Local Highway Authority Response to Planning Consultation

| Planning Application: | 98127/FUL/19 | Pre-app? | No |
| Location: | Unit 1, Altrincham Retail Park, George Richards Way, Altrincham, WA14 5GR | | |

| Planning Application: | 103414/FUL/21 | Response No.: | 02 |

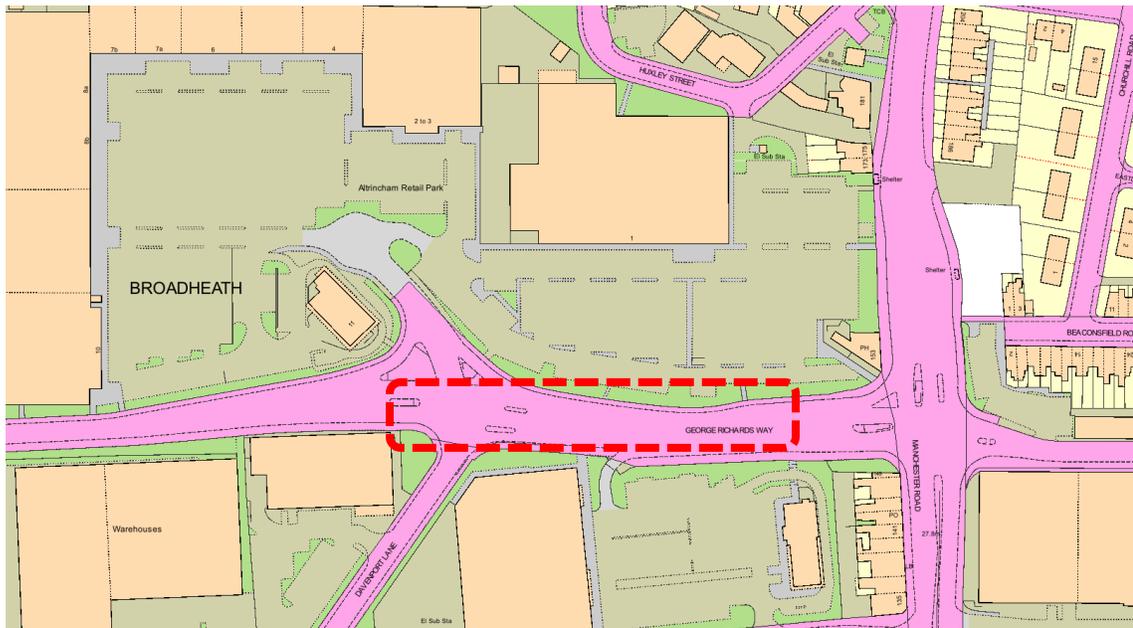
- I. Section 3 of the supporting document states it is proposed to install pedestrian guardrail along the full extent of the proposed traffic island which, has been extended in length to stop vehicles from turning right out of the proposed new access. It is also proposed to reduce the width of the island to 0.950m, with the exception of the ends which would be 1.2m wide (all works would be subject to a S278 Agreement).

- II. The nosing of the island would be 1.2m at each end which, would create a 'dog bone' shaped island. The LHA is concerned that the proposed alignment could potentially lead to a road safety issue as a result of the change in carriageway and kerbline alignment, and therefore requests that the design is amended accordingly. Refer to paragraphs 4.1.3 and 4.1.5 below.

- III. The proposed central island set-back is not clear from the plan provided. For information, for minor road junctions (and subject to the location of the island, including the position of the nosing), the minimum set-back should be 1m from the edge of the running carriageway.

- IV. Further to paragraph 4.1.2 above, physical traffic islands should be clearly visible to approaching drivers. It is accepted that illuminated bollards, and signs, and hazard road markings would be installed; however, drawing number 2019-3538.DWG-204 only shows a partial hatched road marking for the island which could result in vehicle kerb strikes.

- V. Assuming the road markings and other highway features shown on the drawing are representative of what is currently provided on site, it is indicated that the proposed island would impact the existing controlled crossing at the junction with Manchester Road. Therefore, the design team and developer, in consultation with TfGM, should amend the proposals to include the controlled junction, thus providing a single island.

- VI. It is proposed to install pedestrian guard rail along the full length of the island to prevent the central island from being used as a crossing facility. In addition to future maintenance requirements, guard railing can be unsightly, resulting in a cluttered and 'closed' environment. In some instances, cyclists can be pushed across the traffic lane and into the railings. (as noted in research undertaken by Southampton University). Further evidence also suggests people will still walk alongside the railings if they perceive they can shorten their journey by doing so (regardless of the possibility that they may also be putting themselves at greater risk of being struck by a passing vehicle).

- VII. With no physical barrier currently in place vehicles are currently afforded the opportunity to enter the centre hatched area in the event of an incident e.g. to avoid a potential sideswipe collision with another vehicle. Should a traffic incident occur at this location following construction of the island, the proposed guard railing would be another object in the carriageway that could be hit, particularly given the proposed length of railing to be installed. Guard railing should only be introduced where there is a clear, identified need for it.

- VIII. The design team should investigate alternative low maintenance options to encourage pedestrians not to utilise the island as a crossing, that would not denigrate the existing streetscape.

Extract of Adopted Highway

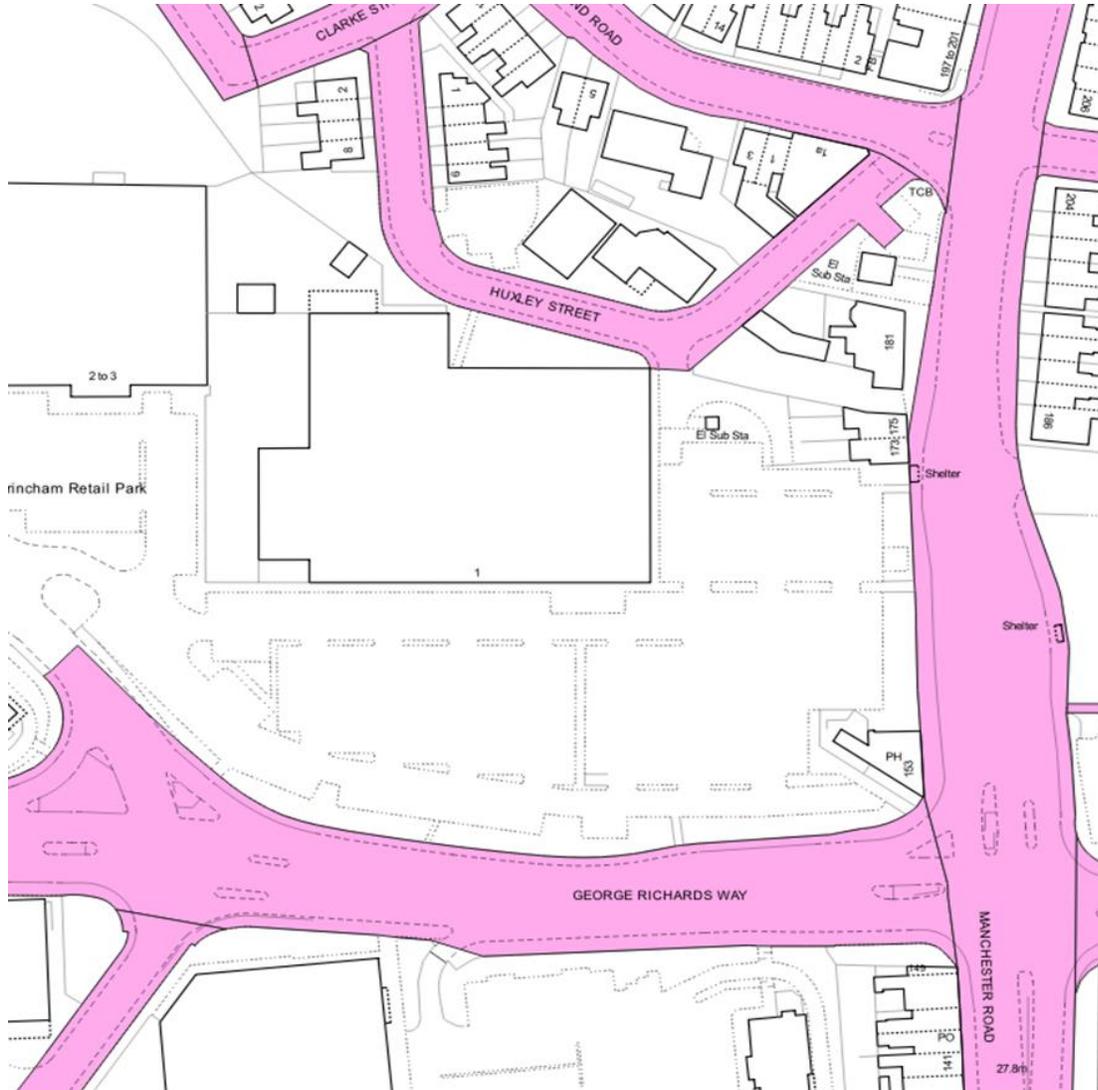
- 5.1.3 The LHA would request a third RSA is completed, for which an Audit Brief should be provided to the RSA team (and copied to the LHA for information). The RSA Audit Brief produced by the developer should request consideration is given to road safety implications for the proposed development for the section of adopted public highway shown inside the dashed red edge box on the plan below, (the adopted public highway is shown shaded pink on the plan):

| | The LHA request a third RSA is completed, for which an Audit Brief should be provided to the RSA team (and copied to the LHA for information). The Audit Brief should request consideration is given to road safety implications for the proposed development for the section of adopted public highway shown inside the dashed red edge box on the plan in para 5.1.3 | A Stage 1 RSA is requested |
